REMARKS

This is in response to the Office Action of January 27, 2004. With this response, claims 1 and 2 are amended, the specification is amended and Figures 1-3 are amended. Entry, consideration and favorable action are respectfully requested.

FIG.1

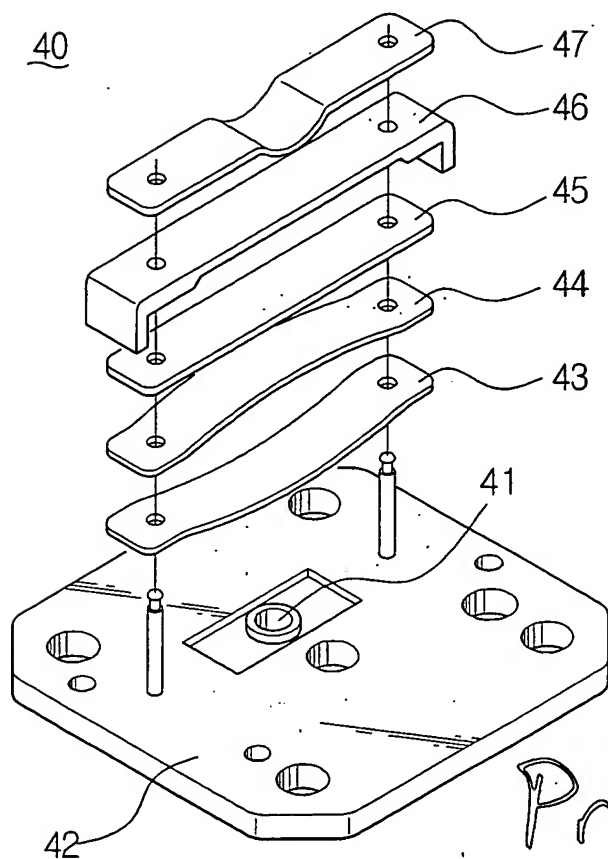
In the Office Action, the Examiner requested that Figures 1-3 be identified as prior art. With this Amendment, those Figures have been amended accordingly.

Prior Art
